Sign Type: With Covers in place

AVALANCHE
SIGN CONTRACTING
786 Hathaway Drive • Colorado Springs, CO 80915
Phone: 719.471.9898 • Fax: 719.632.7781

Project:
Address:
City/State:
Sales Rep: JB
Artist: KF
Date: 01.17.17

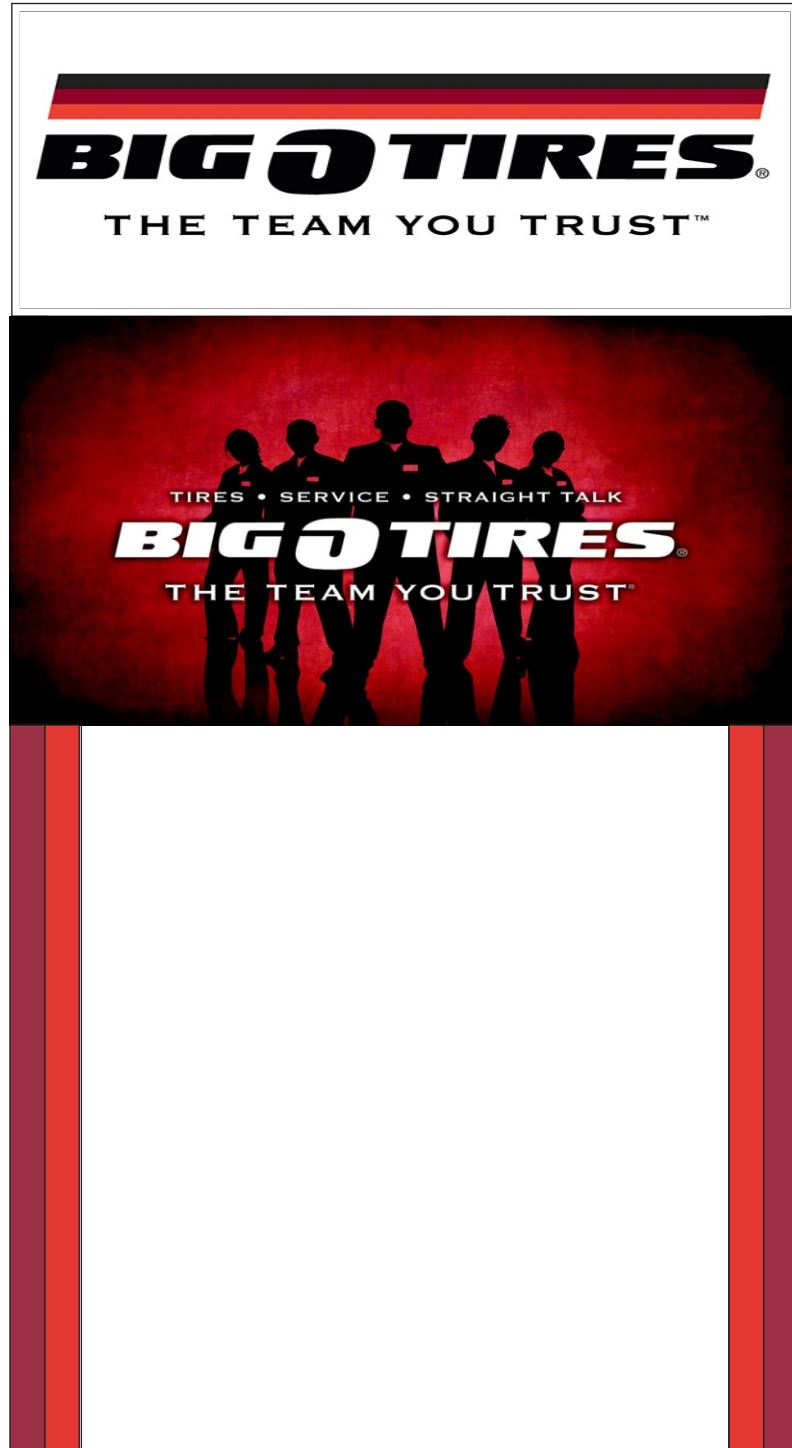
What does "covers in place" mean?

Must show illumination specifics and must meet lighting standards of Ch. 6 of the Land Development Code.

Must show foot candles at property boundaries of .1 or less when abutting public right of way..

Show dimensions, show structure elevations with dimensions.
